**Environmental
Planning
Commission**

**Agenda Number: 10
Project Number: 1001695
Case #: 16EPC-40008
September 8, 2016**

Staff Report

The request is for a site development plan for building permit for an approx. 1.5 acre site at the NE corner of Signal Ave. and Louisiana Blvd. The applicant proposes to develop an allergy clinic.

LANDSCAPE PLAN
 Allergy Clinic
 Albuquerque, NM

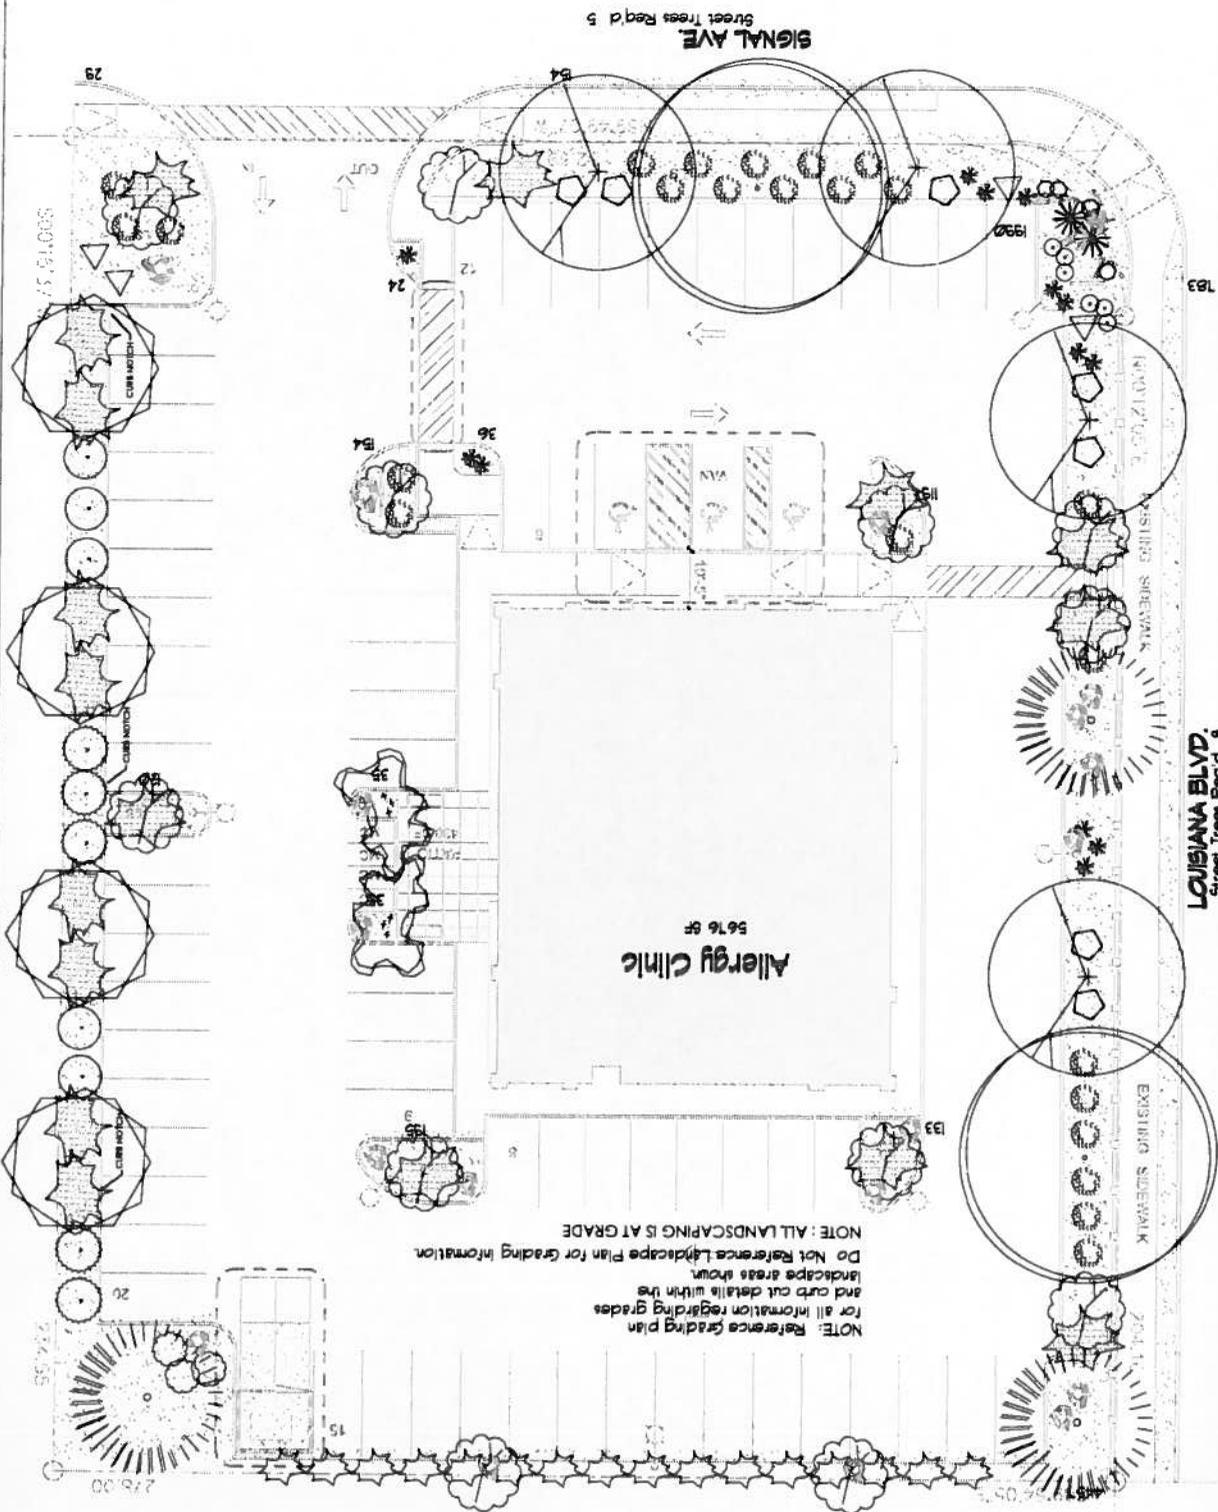
Zoning Code §14-16-3-10, Landscaping Regulations Applicable to Apartment and Non-Residential Development, applies. The minimum requirement for 75% coverage with living, vegetative materials is not met in the landscape bed at the site's SE corner, which has been designated a drainage pond. Staff suggests that the xeric plants not be at the bottom of the pond.

Staff recommends that landscape areas be at grade with the parking areas, so that the curb notches can capture some runoff water for supplemental irrigation. A few in the subject site's SW corner, in the direction of water flow, would be beneficial. Curb notches shown on the landscaping plan need to match the locations of those on the grading and drainage plan.

A curb notch detail is included, but it's unclear where the curb notches would be located. The curb cuts need to be located so that supplemental irrigation water can flow into them, and they need to be shown on the landscaping plan in the same locations as on the grading and drainage plan.

- A. Plants shall be added to the landscaping beds in the site's SE corner to meet the requirement for 75% coverage with living, vegetative materials [§14-16-3-10, Landscaping Regulations].
- B. The SE corner shall be labeled "drainage ponding area", and the inlet shown, to correspond to the grading and drainage plan.
- C. The Ash tree (allergenic) shall be replaced with another tree that is less allergenic.
- D. Juniper shall be listed as "female only".
- E. Landscape areas shall be depressed below grade.

- A. Curb notches on the landscaping plan and the grading and drainage plan shall be shown in the same locations.
- B. At least a couple of curb notches shall be added to the subject site's SW corner, in the direction of water flow.

1 SOUTH ELEVATION - FRONT FACADE
 SCALE 1/4" = 1'-0"

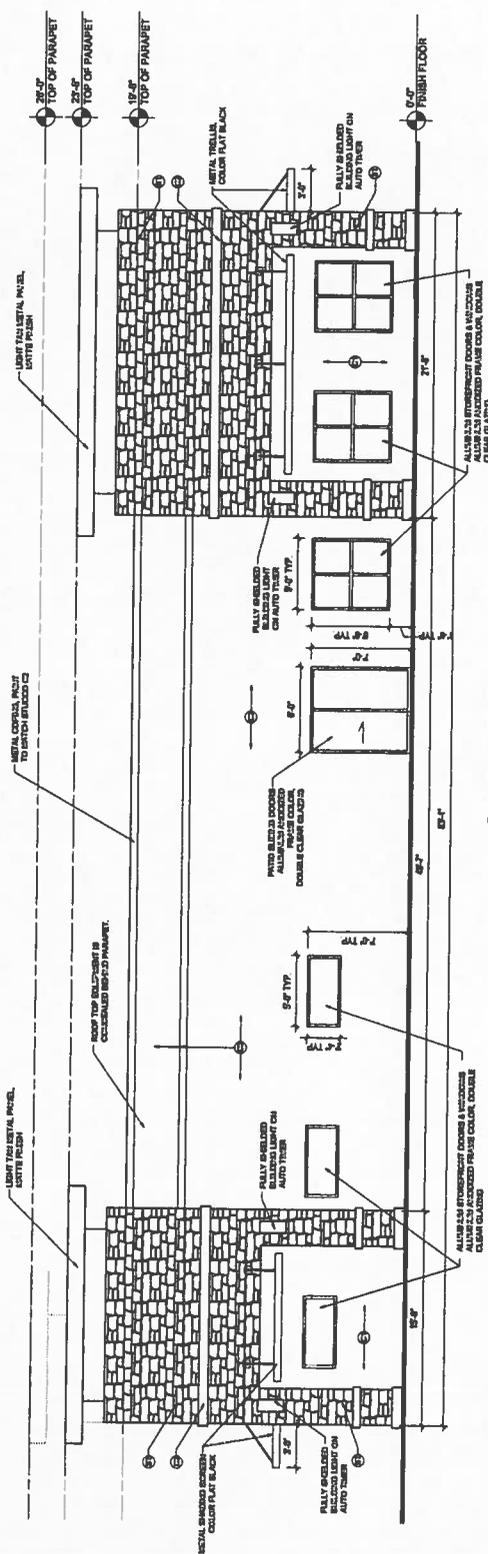
It's unclear on the proposed elevations how far the metal shading screens (canopies) would extend. It's also unclear on Sheet SP-1 what the line on the building's southern and eastern sides is.

Indicate how far the canopies extend and their function and ensure that they help provide an identifiable entrance (LCSDP 5R-7).
